HAVRE DES PAS PEDESTRIAN CROSSINGS

Stage 1 & 2 Road Safety Audit (Rev A)

OUR REF. NO. 62100327-69-01A

**Problem Location Plan
Stage 1 & 2 Road Safety Audit**

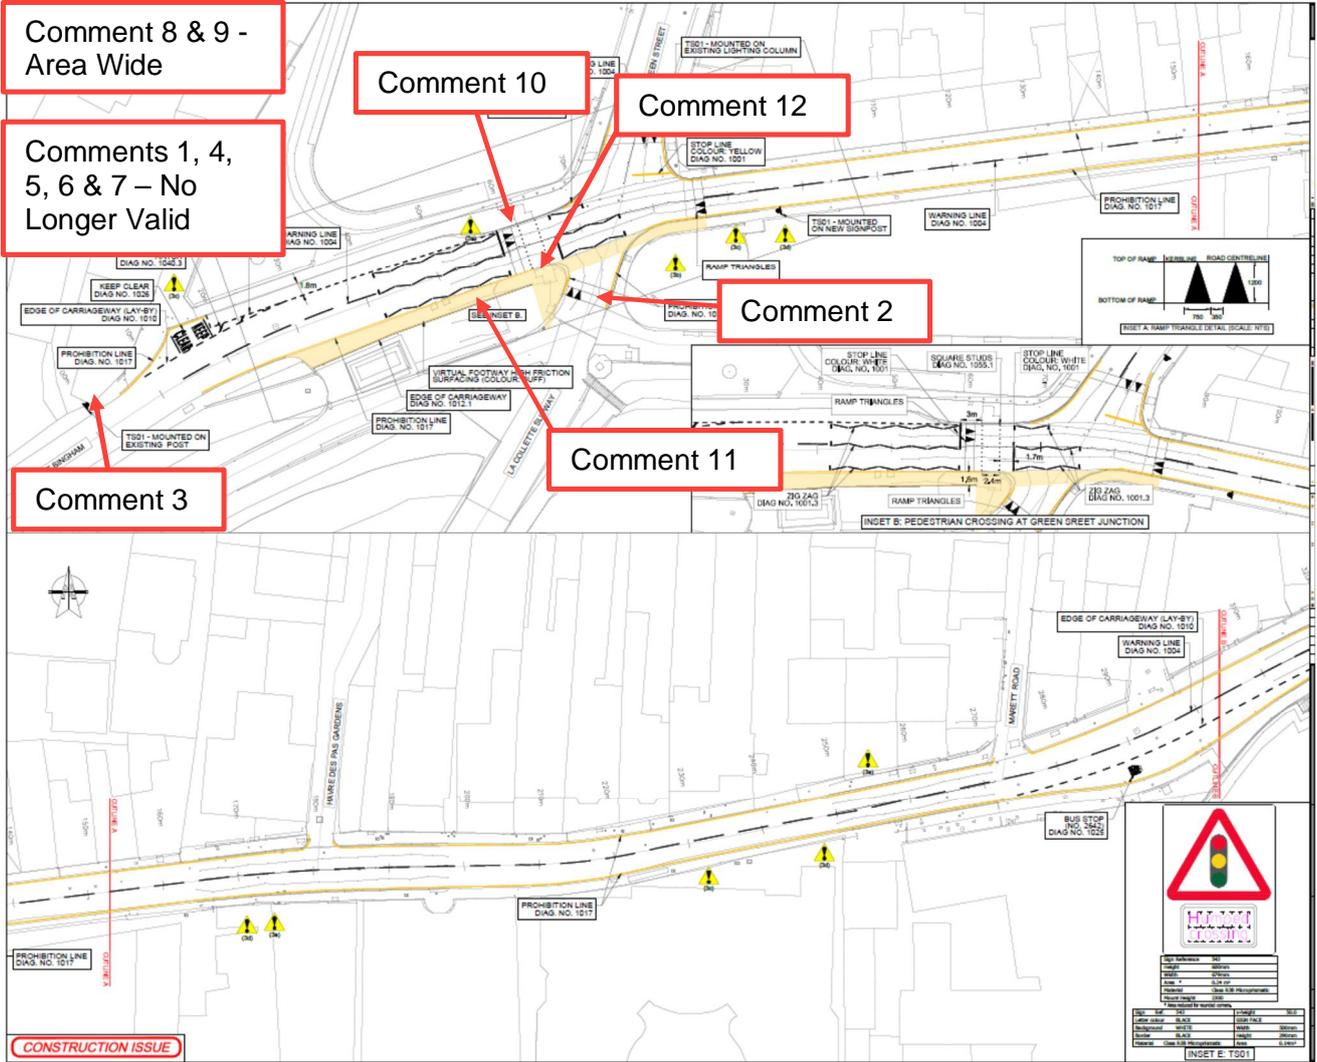
Comment 8 & 9 -
Area Wide

Comments 1, 4,
5, 6 & 7 - No
Longer Valid

Comment 3

Comment 10

Comment 12

Comment 2

Comment 11

Green Street Junction – no level details or sections have been provided for the raised table at this junction. The drawings show a ramp on the southern approach to the table, which starts a few metres in front of a cobbled section of slipway and close to the seafront promenade. A ramp at this location could cause an unnecessary hazard for pedestrians as well as be difficult to tie in to on its eastern side (where the adjacent levels are flush). The need for a ramp at this location is unclear as approach speeds will be very low. It is recommended that the levels on this southern side of the junction are checked to ensure that an appropriate solution is achieved. **Comment still valid in this revision of the RSA Report, although it is understood that level checks have been made.**

Western approach to the Green Street Junction – traffic signs TS01 & TS02 are shown in close proximity to each other. Although not considered to be a problem, it is recommended that checks are made to ensure that the larger sign (TS02) does not obstruct visibility to the 20mph sign (TS01) located behind it. **Comment still valid in this revision of the RSA Report, although it is understood that appropriate checks have been made.**

Area Wide – 20mph signs are to be installed at either end of Havre des Pas, which is within an existing 20mph limit. The audit team did not check to see whether the 20mph limit is also signed in each side road. The validity of the 20mph speed limit could be questioned if it is not signed on the side roads joining it. **The 20 mph signs previously proposed for Havre des Pas have been omitted in from the latest version of the drawings. Check that adequate repeater signs are provided along the length of Havre des Pas.**

In addition, the Highways (Road Humps) (Jersey) Regulations 2002 requires that all road humps are signed with traffic sign No. 557.1 in combination with traffic sign No. 557.2, 557.3 or 557.4. It is noted that where the speed humps are within a 20mph the Highway Authority, in consultation with the Minister, may decide that these signs are not required. **Comment still valid in this revision of the RSA Report.**

There are a few anomalies with the road markings shown on the current version of drawings 1964/1200/001 & 1964/1200/002.

Green St Junction & the Crossing near Roseville Junction - The central zig zag markings on the eastern side are the wrong way around. On the approaches to the crossing the zig zag markings should run in parallel, with the marks converging and diverging on the exit side.

Crossing near Roseville Junction - The zig zags are not in pairs (ie an odd number, not even). This means that the last mark does not tie into the kerb. Either extend or reduce by one mark.

Zebra crossing outside Ommaroo Hotel – Check the configuration of the striped markings to ensure that the first white stripe is away from the kerb face.

Green St Junction – the tactile paving at the signalised crossing doesn't appear to line up correctly.

Green St Junction – high friction surfacing has been proposed for the virtual footway on the southern side of the junction. Pedestrians that trip and fall on to the surface may sustain more severe injuries than if a less abrasive surfacing material is used.

Green St Junction – buff coloured high friction surfacing has been proposed for the virtual footway on the southern side of the junction. Buff coloured tactile paving has also been proposed at the crossing and therefore it is important to provide adequate contrast for visually impaired pedestrians.
